UNITED STATES  
NUCLEAR REGULATORY COMMISSION  
WASHINGTON, D. C. 20555

November 7, 1989

SUBJECT: INSTALLATION OF A HARDENED WETWELL VENT (GENERIC LETTER 89-16)

REVISED INFORMATION REGARDING PILGRIM STATION  
SAFETY ENHANCEMENT PROGRAM

FIGURE 3.2-1

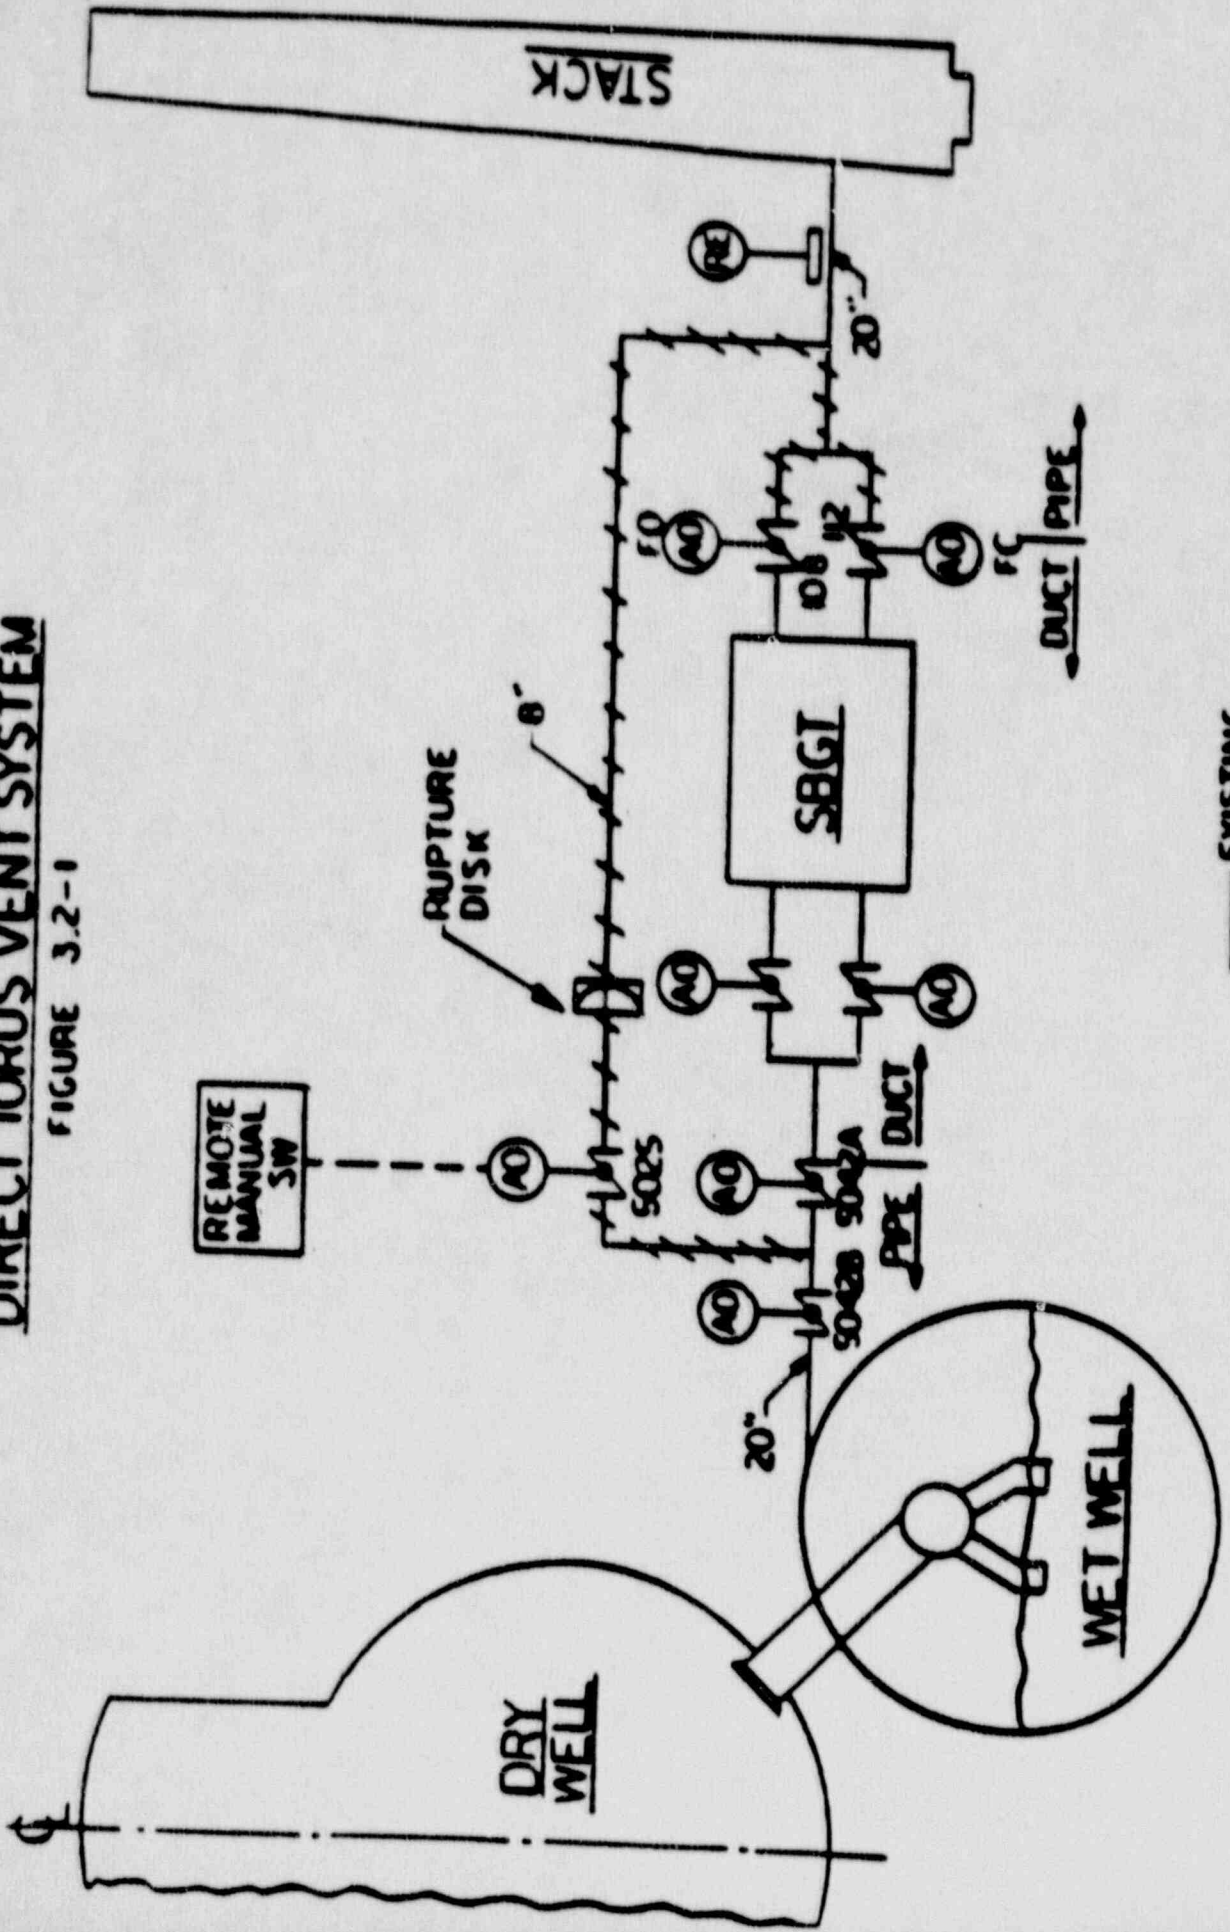
This design change (Figure 3.2-1) provides a direct vent path from the torus to the main stack bypassing the Standby Gas Treatment System (SBGTS). The bypass is an 8" line whose upstream end is connected to the pipe between primary containment isolation valves AO-5042 A & B. The downstream end of the bypass is connected to the 20" main stack line downstream of SBGTS valves AON-108 and AON-112. An 8" butterfly valve (AO-5025), which can be remotely operated from the main control room, is added downstream of 8" valve AO-5042B. This valve acts as the primary containment outboard isolation valve for the direct torus vent line and will conform to NRC requirements for sealed closed isolation valves as defined in NUREG 0800 SRP 6.2.4. The new pipe is ASME III Class 2 up to and inclusive of valve AO-5025. Test connections are provided upstream and downstream of AO-5025.

The design change replaces the existing AC solenoid valve for AO-5042B with a DC solenoid valve (powered from essential 125 volt DC) to ensure operability without dependence on AC power. The new isolation valve, AO-5025, is also provided with a DC solenoid powered from the redundant 125 volt DC source. Both of these valves are normally closed and fail closed on loss of electrical and pneumatic power. One inch nitrogen lines are added to provide nitrogen to valves AO-5042B and AO-5025. New valve AO-5025 will be controlled by a remote manual key-locked control switch. During normal operation, power to the AO-5025 DC solenoid will also be disabled by removal of fuses in the wiring to the solenoid valve. This satisfies NUREG 0800 SRP 6.2.4, Containment Isolation System acceptance criteria for a sealed closed barrier. An additional fuse will be installed and remain in place to power valve status indication for AO-5025 in the main control room.

A 20" pipe will replace the existing 20" diameter duct between SBGTS valves AON-108, AON-112 and the existing 20" pipe to the main stack. The existing 20" diameter duct downstream of AO-5042A is shortened to allow fitup of the new vent line branch connection.

A rupture disk will be included in the 8" piping downstream of valve AO-5025. The rupture disk will provide a second leakage barrier. The rupture disk is designed to open below containment design pressure, but will be intact up to pressures equal to or greater than those which cause an automatic containment isolation during accident conditions.
